ADDENDUM #08

INVITATION TO BID #01

ACES at CHASE

STATE PROJECT NO. 244-0044 MAG

3 LOBBY 101-6 - ELEVATION C
1/2" = 1'-0"

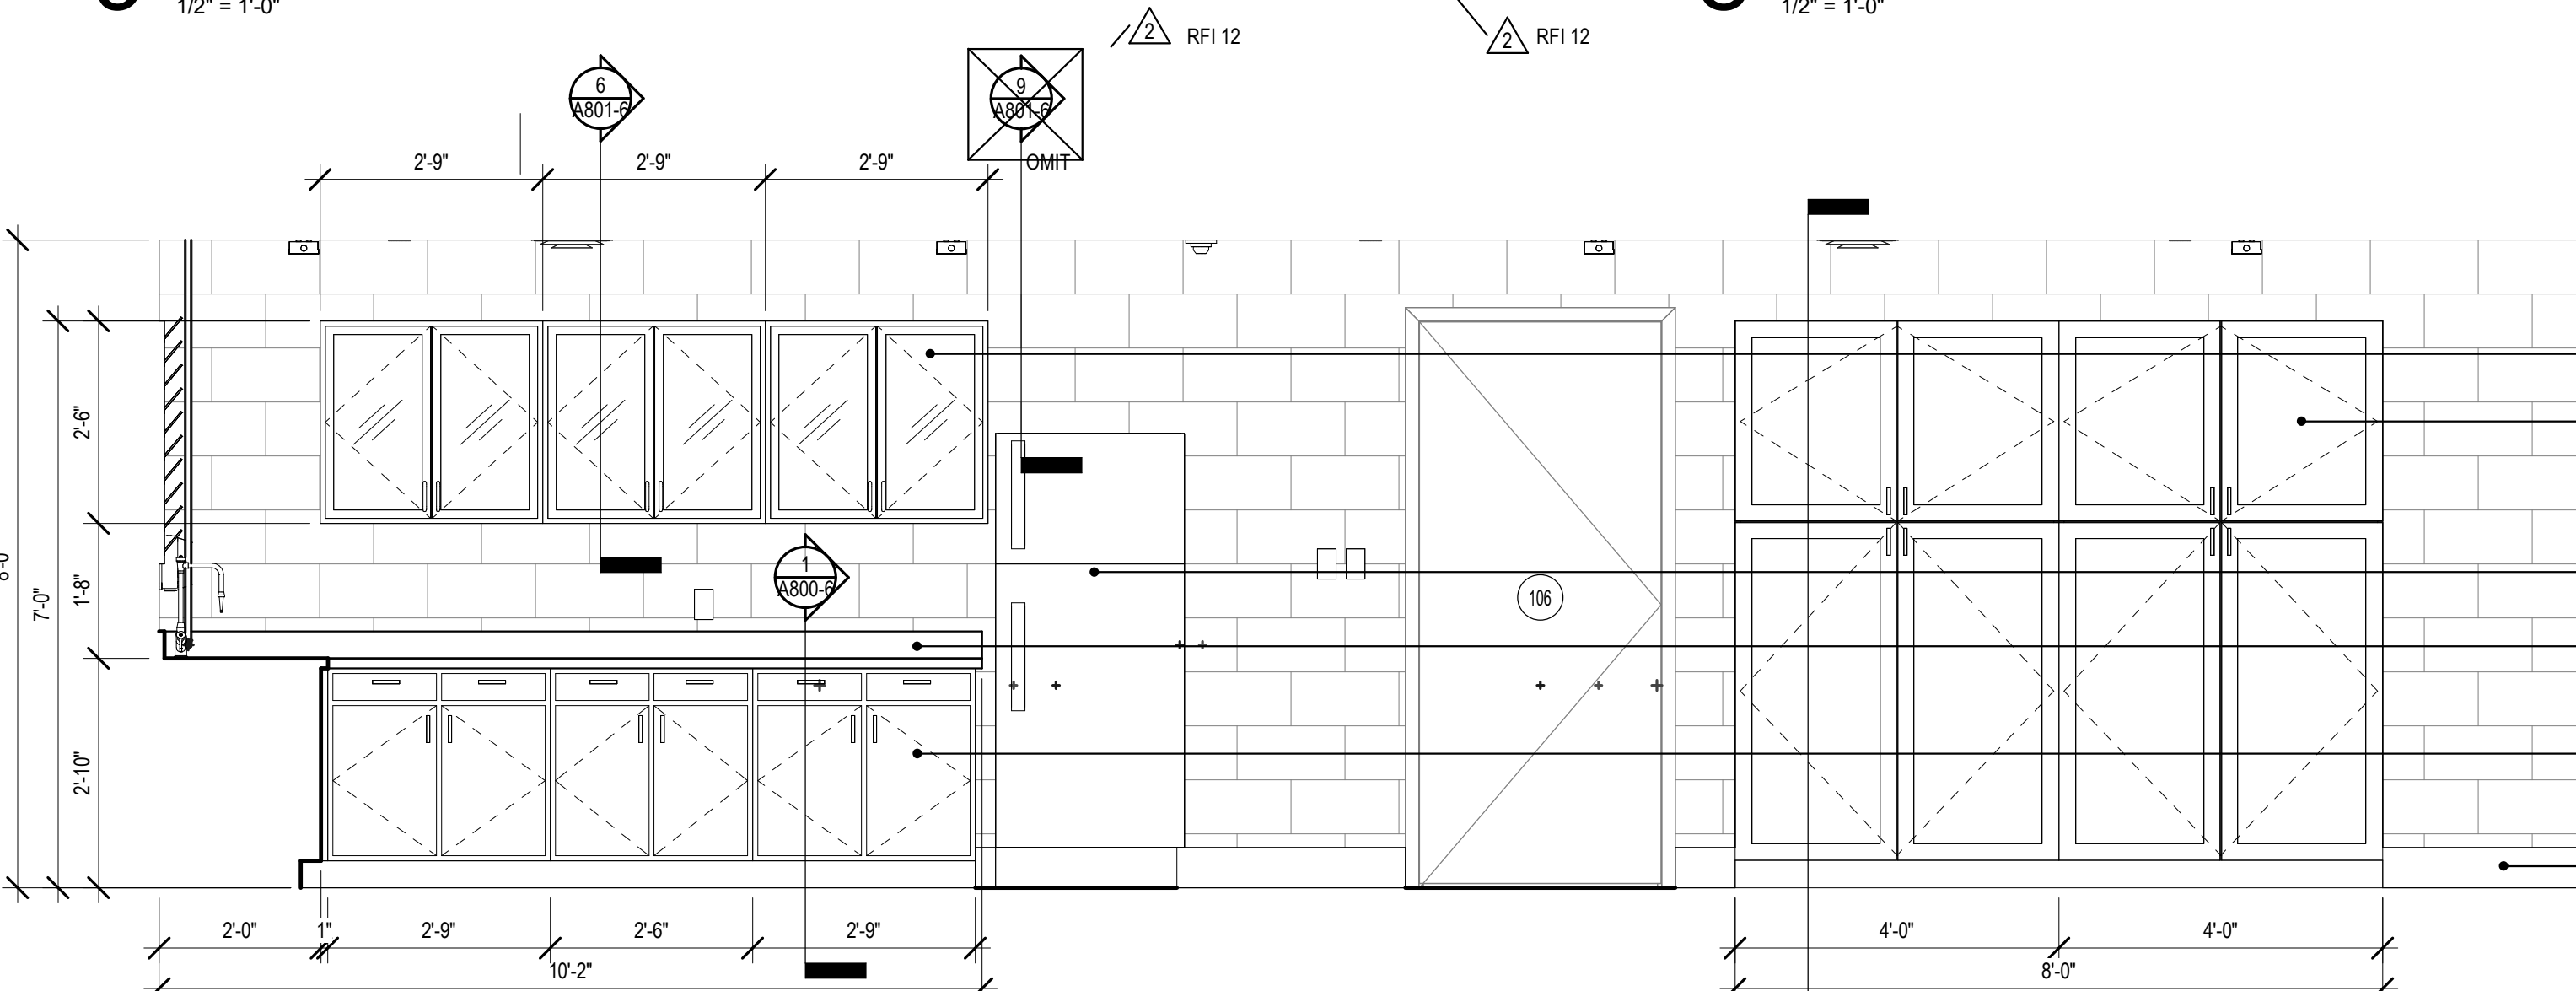
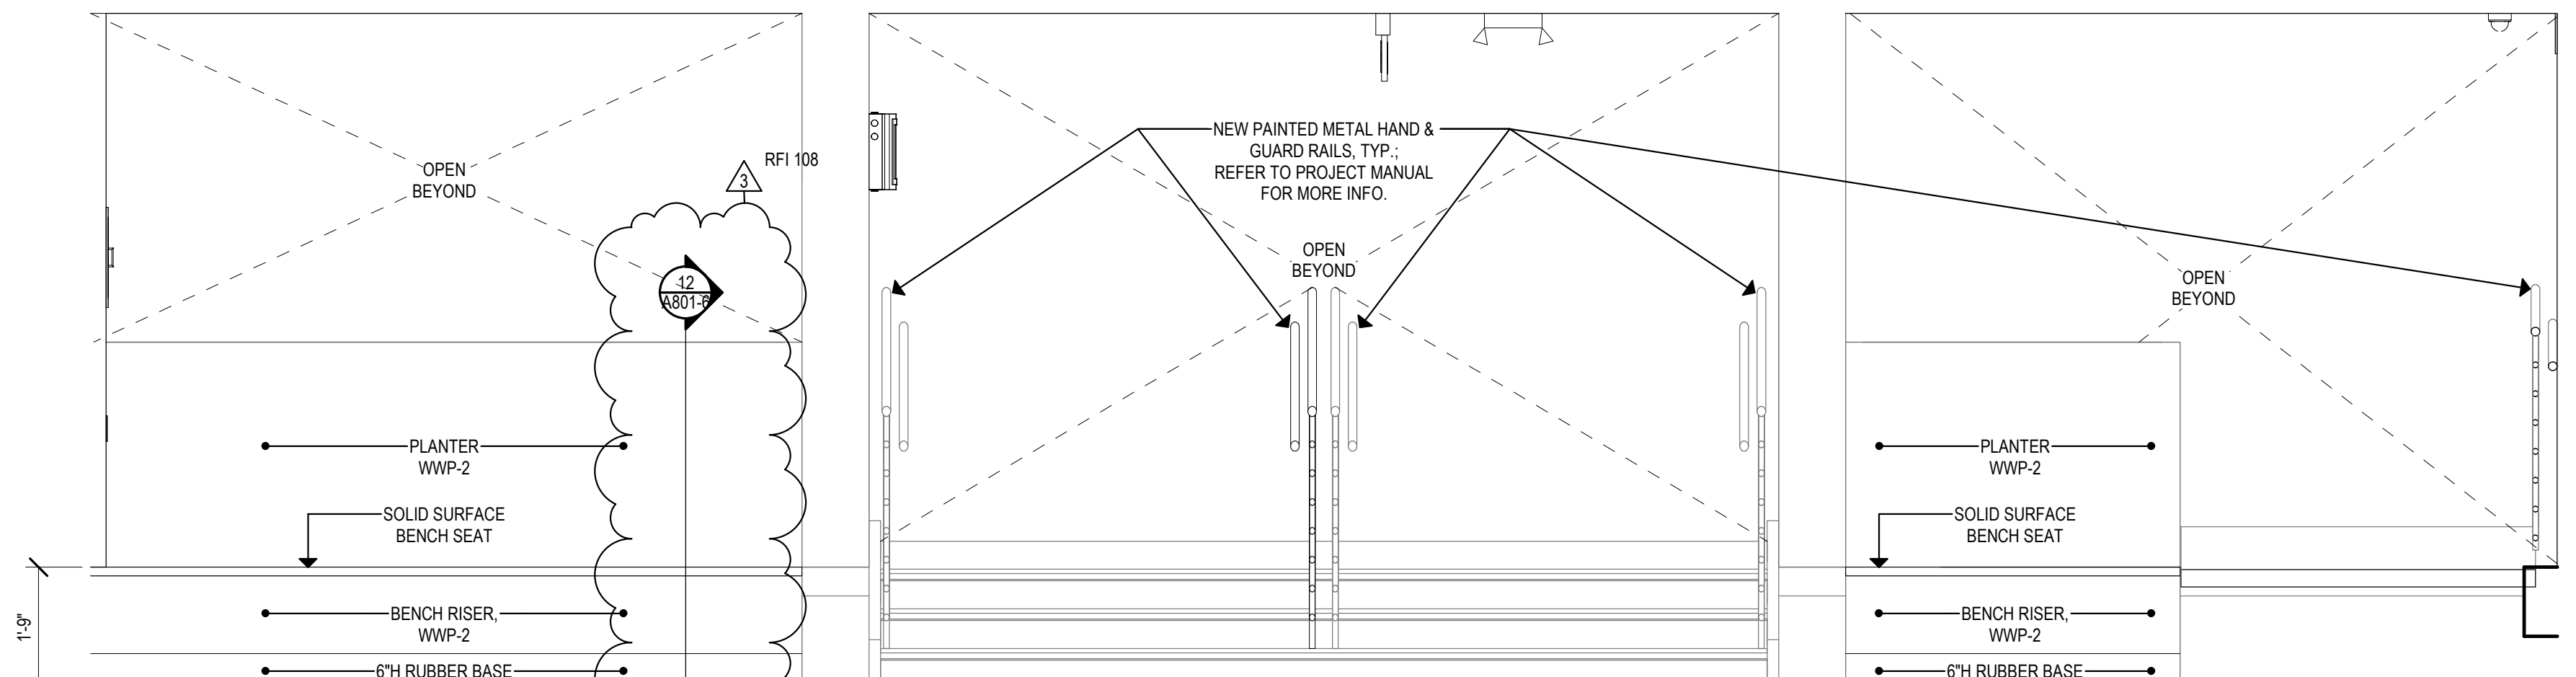
Add Item #145 RFI #12 (Building 6) **Question:** Is elev 4/A733 applicable to Classroom 139 and 142, reverse at 140, 143? And is key through taller base cabinets supposed to read 2/A801? **Answer:** Correct. No, Detail Tag to read 1/A800-6. Refer to Bulletin #3 for revised Drawing A733. -S/P+A-KD

- Elev 7/A733 has a floating detail key 9/A801 above the refrigerator. Is an upper cabinet to be provided? **Answer:** No. Refer to Bulletin #3 for revised Drawing A733. -S/P+A-KD

- Details 1, 2, and 3/A801 appear to be applicable to Lab Casework and Manufactured Solid Plastic Casework only; please clarify and revise details if necessary. **Answer:** Detail tags at Elevation 9/A733-6 are for countertop only. Refer to Bulletin #3 for revised Drawings A733-6 & A801-6. -S/P+A-RSB/KD
